FINAL SUPPLEMENT
ENVIRONMENTAL IMPACT
STATEMENT
MODIFICATION PROJECT
BIG STONE LAKE -
WHETSTONE RIVER

FINAL SUPPLEMENT
ENVIRONMENTAL IMPACT STATEMENT
MODIFICATION PROJECT
BIG STONE LAKE-WHETSTONE RIVER
BIG STONE AND LAC QUI PARLE COUNTIES, MINNESOTA, AND
GRANT COUNTY, SOUTH DAKOTA

APPENDIX 1:
LETTERS OF COMMENT
AND ST. PAUL DISTRICT RESPONSES

PLATE I

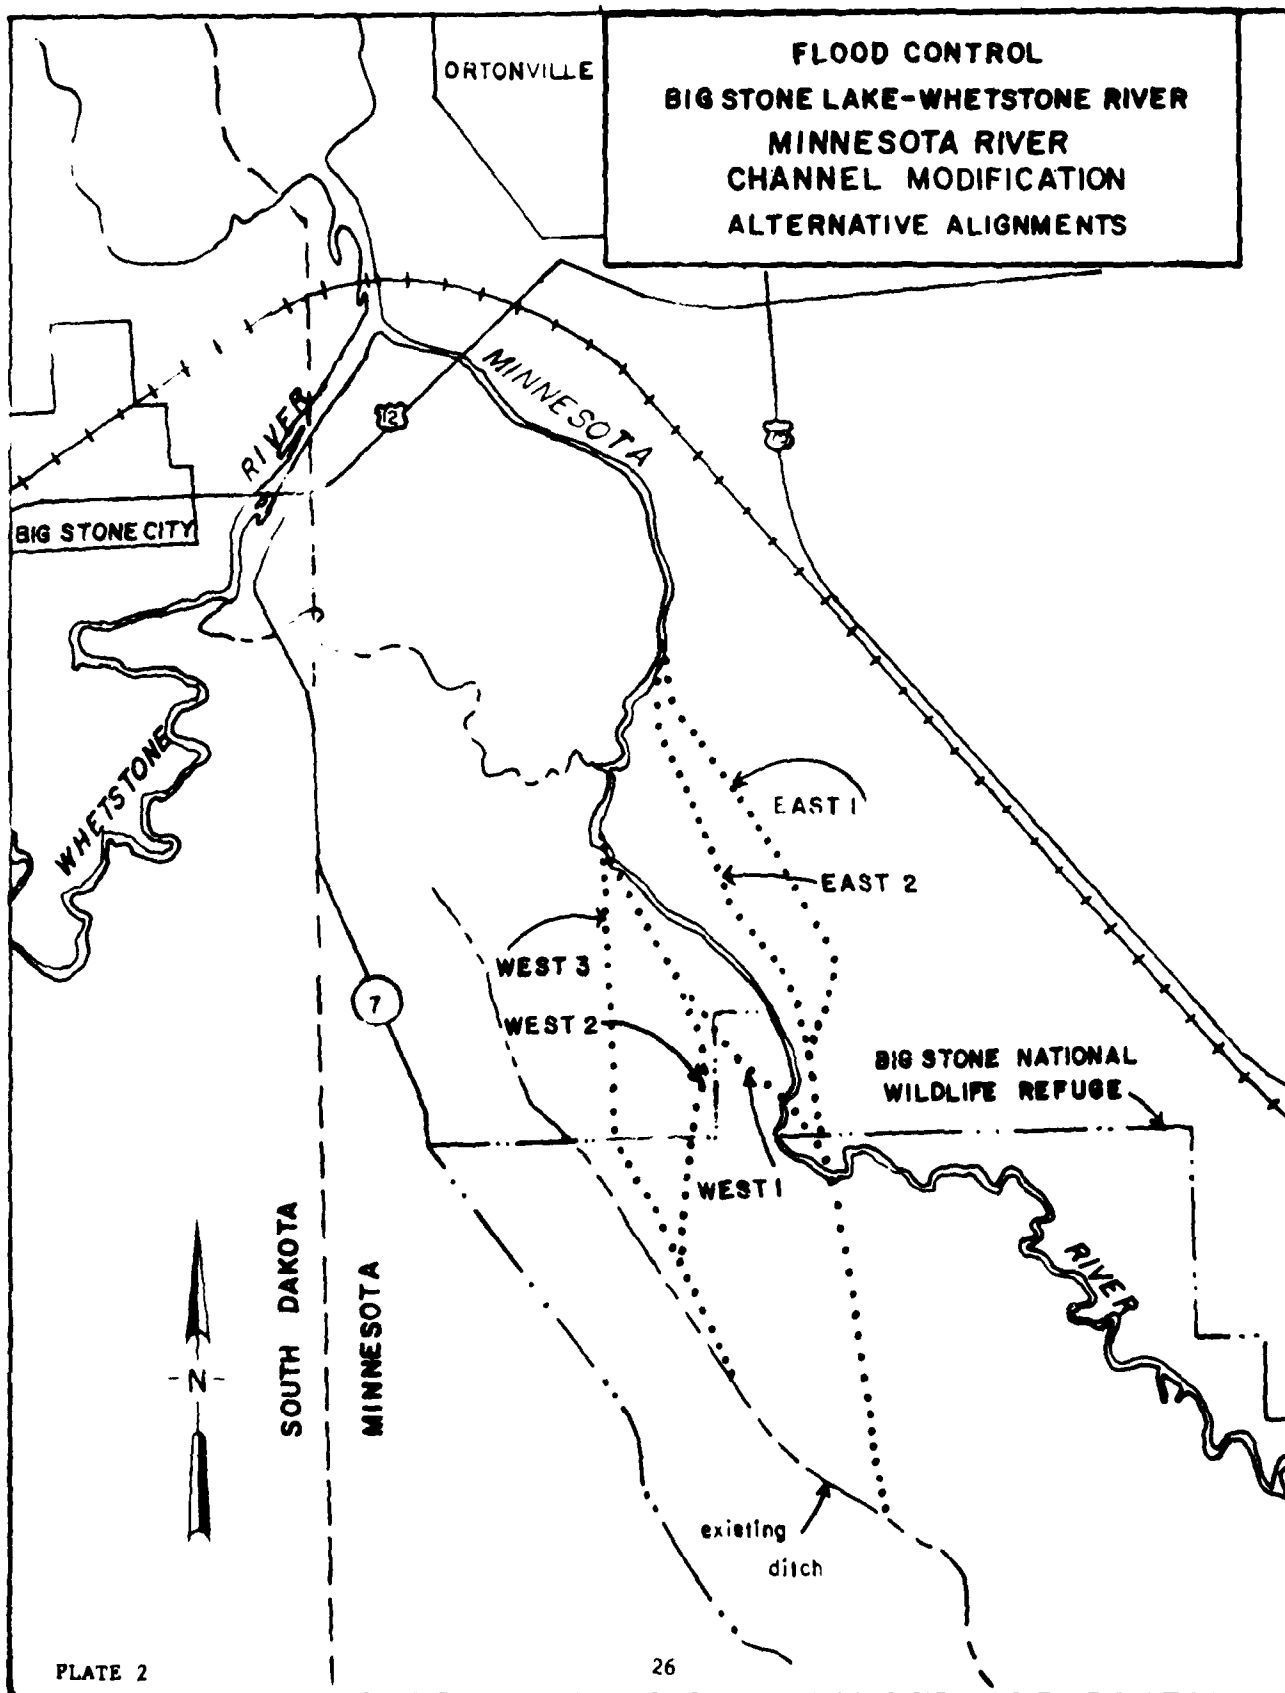
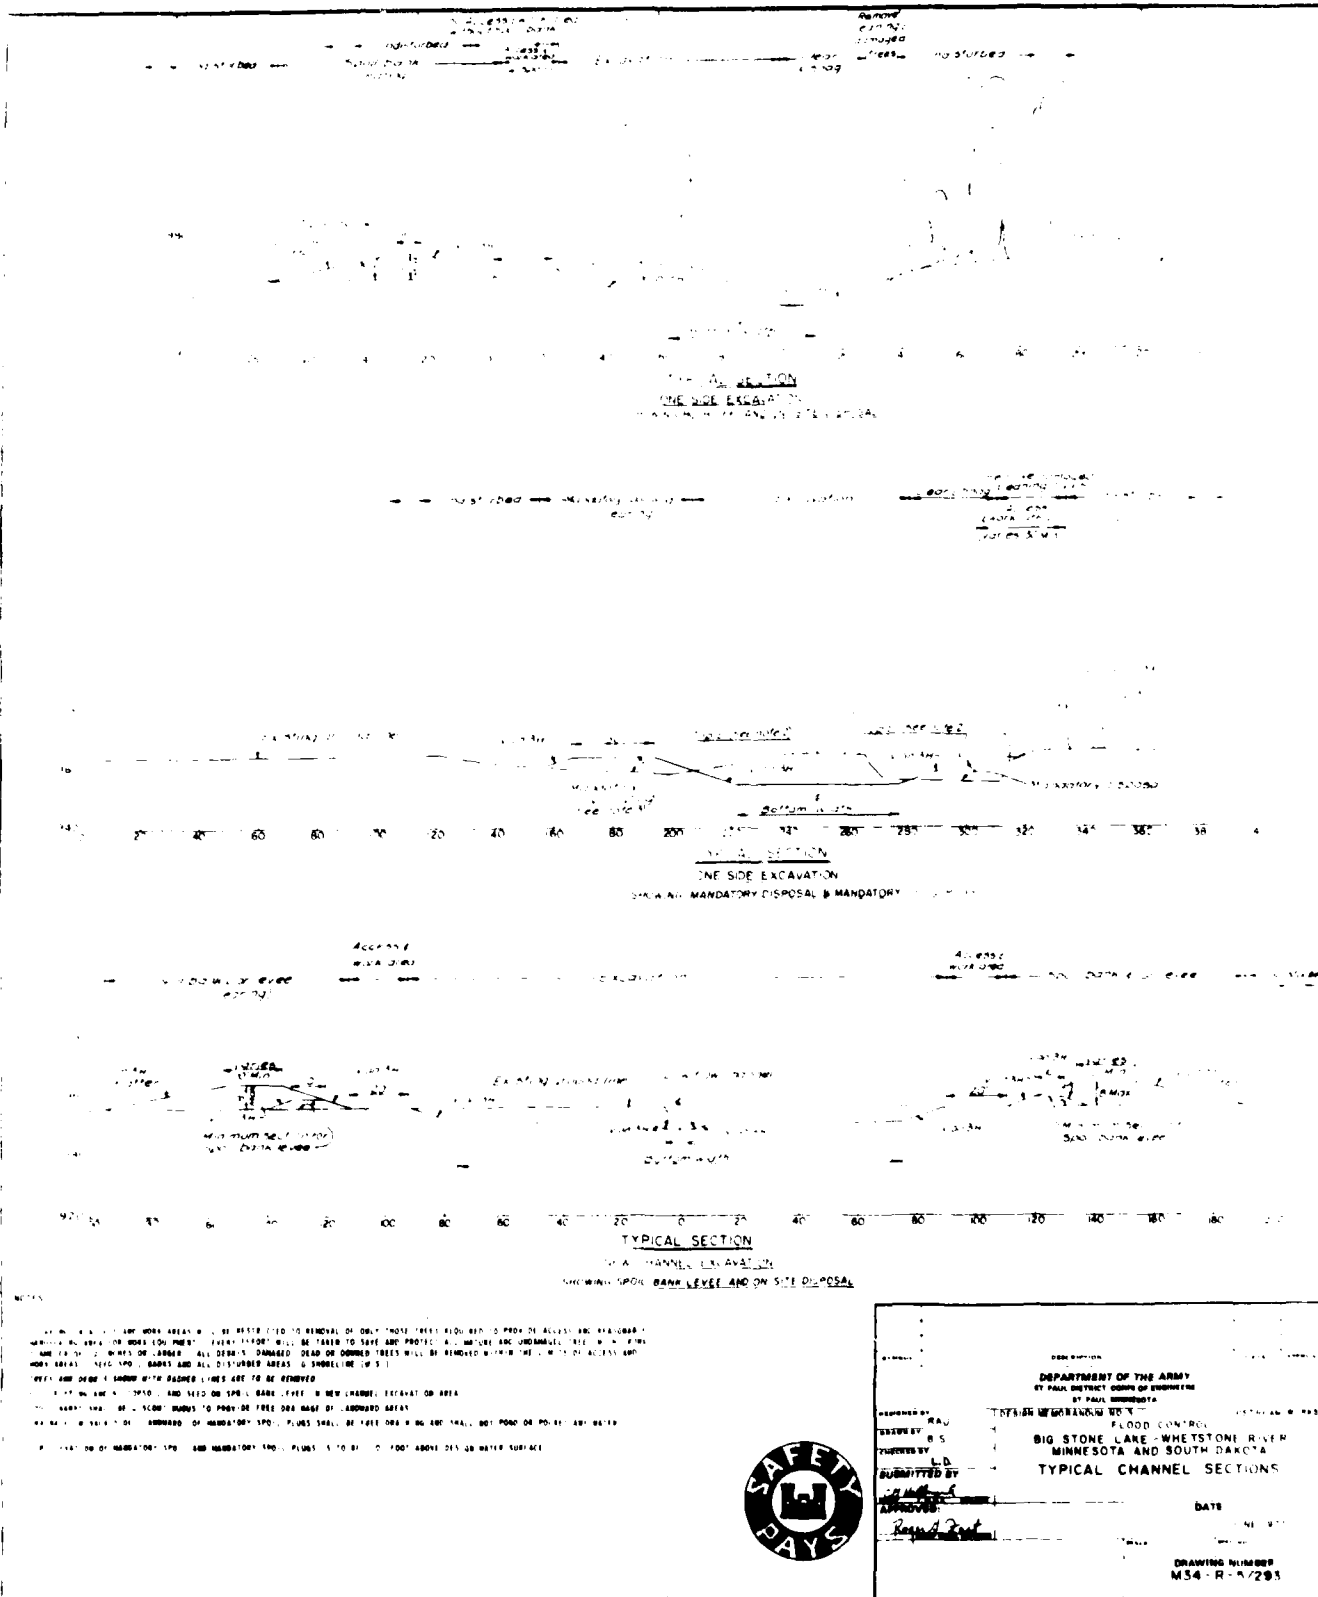
Maintenance of the 200 foot channel width from the intersection with the Minnesota River all the way to the drainage ditch is inconsistent with information presented the Fish and Wildlife Service during previous interagency meetings. In those earlier discussions, the full width channel was proposed to be terminated 1,000 feet or more from the drainage ditch. Because the change would directly affect operation of Big Stone National Wildlife Refuge, the rationale for that change should be provided.

2. The weir referred to in the third sentence is the upstream weir in the diversion channel as shown on Plate 1. The weir is designed to control flows up to elevation 927 feet (2.5 feet above the channel bottom). The plan also includes an additional weir downstream of the existing river channel to divert flows up to 200 cfs into the existing river channel.
